**Economic and Social Council**Distr.: General
8 August 2024

Economic Commission for Europe**Inland Transport Committee****World Forum for Harmonization of Vehicle Regulations****Working Party on Lighting and Light-Signalling****Ninety-first session**

**UN Regulations on Light Sources and the Consolidated Resolution
on the Common Specification of Light Source Categories****Proposal for amendment 11 to the Consolidated Resolution
on the Common Specification of Light Source Categories****Submitted by the expert from the International Automotive Lighting
and Light-Signalling Expert Group***

Figure 1*

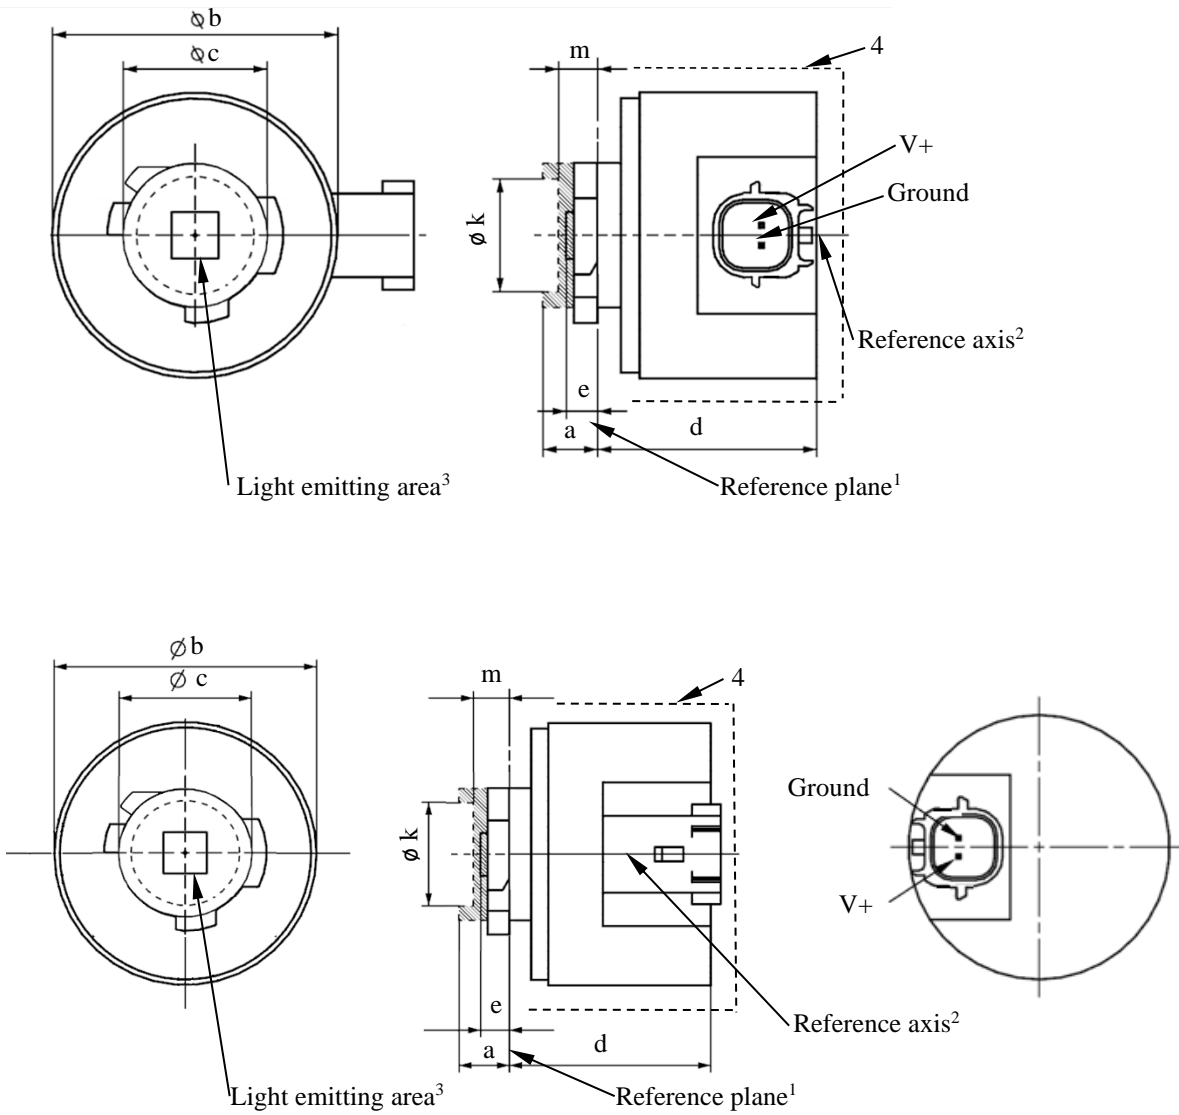
After sheet Lx6/6, insert new sheets Lx7/1 to 6, to read (see the following pages; one page per sheet):

The drawings are intended only to illustrate the essential dimensions of the LED light source.

Dimensions		Production LED light sources	Standard LED light sources
a	mm	6.0 max.	
b	mm	c + 10.0 min. 38.0 max.	
c	mm	18.5 ± 0.1	
d	mm	28.0 max.	
e ^{8/}	mm	3.0 ± 0.30	3.0 ± 0.15
k ^{9/}	mm	7.5 min.	
m ^{9/}	mm	4.0 max.	
Cap LW7A, LW7B PGJ18.5d-36 in accordance with IEC Publication 60061 (sheet 7004-185-3)			
<i>Electrical and photometric characteristics</i>			
Rated values	Volts	12	
	Watts LW7A, LW7B	8	
Test voltage	Volts (DC)	13.5	
Objective Values ⁶	Watts (at test voltage) LW7A, LW7B	9 max.	
	Luminous flux (in lm at test voltage) ⁵ LW7A, LW7B	750 ± 20%	750 ± 10% ⁷
	Luminous flux (in lm at 9 V DC) ⁵ LW7A, LW7B	150 min.

Figure 2

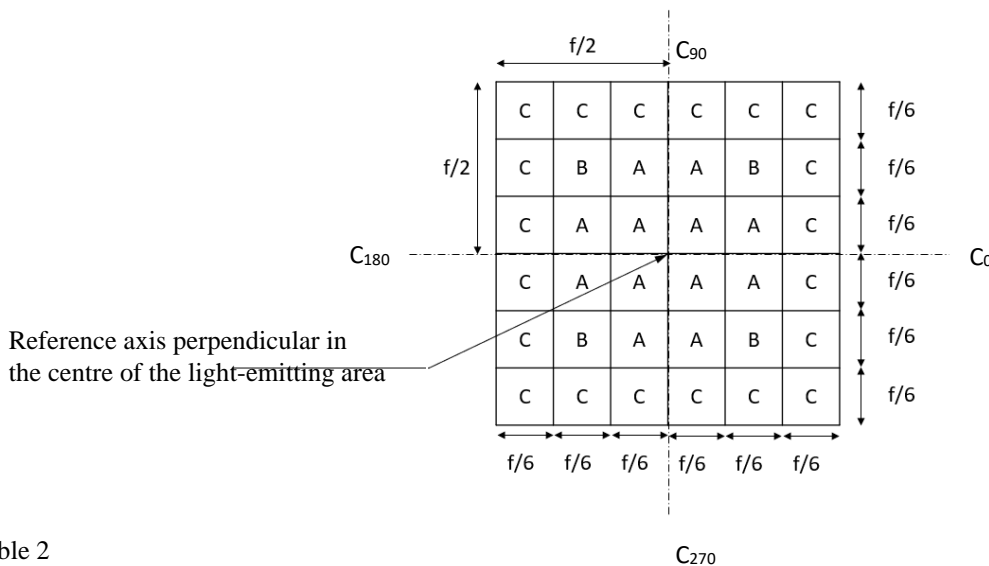
The position of the light emitting area is checked by the box system defined in Figure 2, which is aligned to the planes C₉₀ and C₁₈₀ and shows the projection when viewing along direction $\gamma = 0^\circ$ at $e = 3.0$ mm (C, γ as defined in Figure 3). The luminous flux Φ emitted into the viewing direction shall be calculated as given below:

The distribution of luminous flux originating from the LEA as shown in Figure 2 shall fulfil the requirements given in Table 3. All numbers shall be given in % of the total luminous flux emitted into the viewing direction from the bayonet core area, i.e. a circular area with diameter $c = 18.5$ mm (see Figure 1).

Dimensions in mm	f
LED light sources of normal production	4.8
Standard LED light sources	4.8

<i>Category</i>	<i>Area(s)</i>	<i>LED light sources of normal production</i>	<i>Standard LED light sources</i>
LW7A, LW7B	Each A individually	> 3% < 10 %	> 3% < 10%
	Each B individually	> 3% < 10%	> 3% < 10%
	All A and B together	> 65%	> 70%
	Each C individually	< 3%	< 3%
	All A, B and C together	> 90%	> 90%

Figure 3

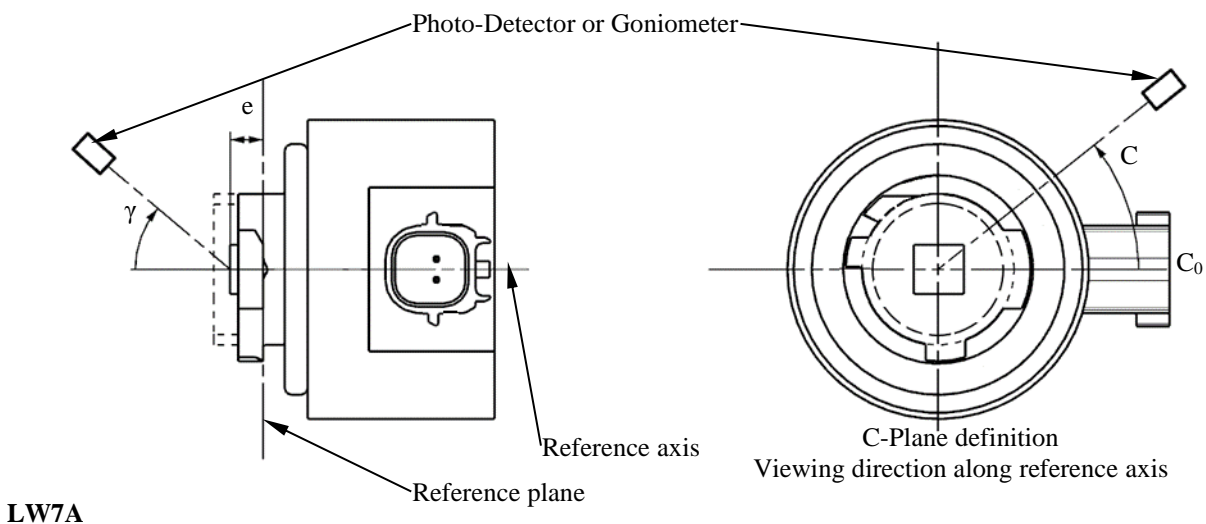
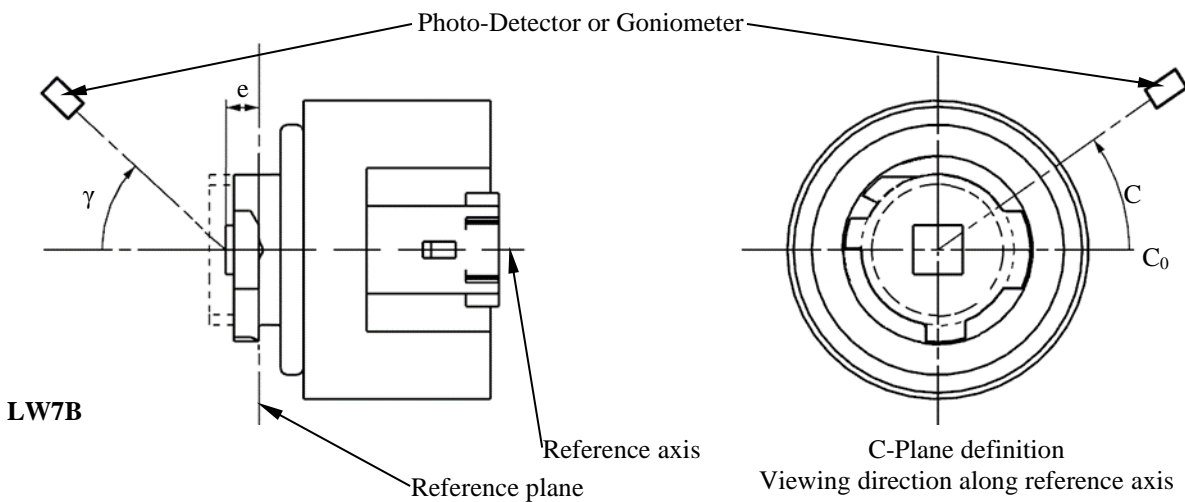
The following test is intended to determine the normalized luminous intensity distribution of the light source in an arbitrary plane containing the reference axis. The intersection of the reference axis and the parallel plane to the reference plane in distance $e = 3.0 \text{ mm}$ is used as the coordinate system origin.

The light source is mounted on a flat plate with the corresponding mounting lug features. The plate is mounted to the goniometer table by a bracket, so that the reference axis of the light source lines up with one of the rotating axes of the goniometer. The corresponding measurement set-up is described in Figure 3.

The measurements shall be performed in C-planes C_0 , C_{90} , C_{180} and C_{270} , which contain the reference axis of the light source. The test points for each plane for multiple polar angles γ are specified in Table 4.

The measured luminous intensity values, normalised to the measured luminous flux of the individual light source under test, shall be converted to normalised luminous intensity values of a 1,000 lm light source. The data shall comply with the tolerance band as defined in Table 4.

<i>Angle γ</i>	<i>LED light sources of normal production</i>		<i>Standard LED light sources</i>	
	<i>Minimum Intensity in cd /1000 lm</i>	<i>Maximum Intensity in cd/1000 lm</i>	<i>Minimum Intensity in cd /1000 lm</i>	<i>Maximum Intensity in cd /1000 lm</i>
0°	200	425	250	390
15°	190	415	240	370
30°	170	380	220	335
45°	145	310	180	275
60°	85	245	105	220
75°	0	160	0	150
90°	0	70	0	65
